## Parkside Cemetery -- Dundas Information Session Tuesday, February 19, 2019

**My comments / some thoughts on the design:**

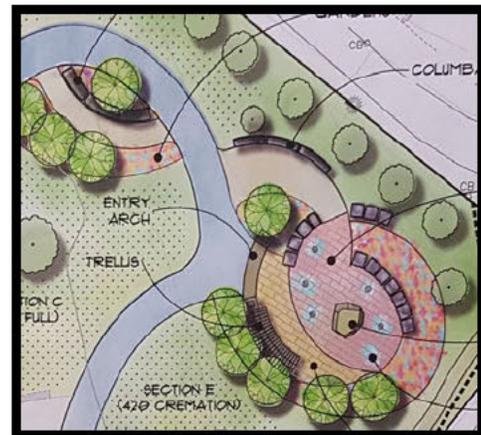
The Columbarium Areas are situated nicely along the paths that are intersected by the main asphalt path and leads smoothly to the commemorative rock area. But the western-most columbarium, with the outward convex curve, should be located on the other side of that pathway and curved inwards (concave) so as to look more inviting. The staggered locations would also offer greater visual variety and interest.

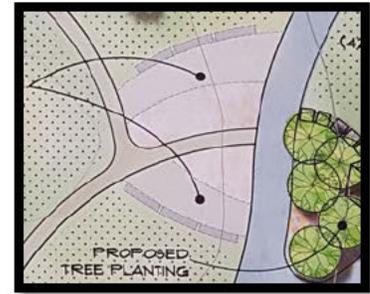
Assuming that the in-ground water spray nozzles would work intermittently, when activated, that action may disturb anyone there for some quiet time.

Perhaps the commemorative rock could incorporate a continuous gentle-running water fountain with a catchment area at the rock base, if not a small decorative pond. I think the sound of the water over rock would encourage a more contemplative behaviour, both visually and acoustically. If the in-ground nozzles are to be continuously running, the water heights should be fairly low (less than 1m), but they may present a potential safety hazard for patrons.

The 'Look-out' should have minimal vegetation impeding the vista of anyone situated in the gazebo looking out towards the Driving Park. At most, any proposed vegetation should be low-lying in the foreground. Perhaps taller vegetation may be used to 'frame' selected views.

The rock seating wall can be utilized as a bottom frame in the foreground for viewers situated in the gazebo, but sitters on the rock wall will have the option of sitting and viewing the scenery towards the gazebo or outwards into the Driving Park.
